COMMITTEE OF ADJUSTMENT

MINOR VARIANCE REPORT

APPLICATION: CAV A/184/2022

CAV A/184/2022 - 169 Pinehurst Drive (East District) (OP Designation: Low Density Residential)

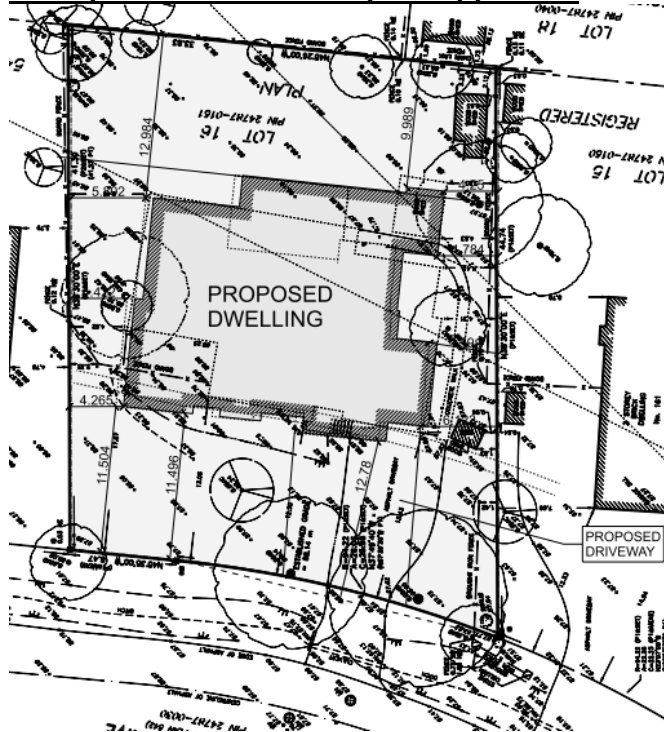
The applicant is requesting relief from Zoning By-law 2014-014, as amended, to permit an increase in maximum garage floor area from 56 square metres to 56.34 square metres for a total increase of 0.34 square metres. The intent of regulating the garage floor area is to prevent the garage from being a visually dominant feature of the dwelling does not present negative impacts to the streetscape. Staff are of the opinion that the increase in the Garage floor area is interrelated with other variances and hence not supported.
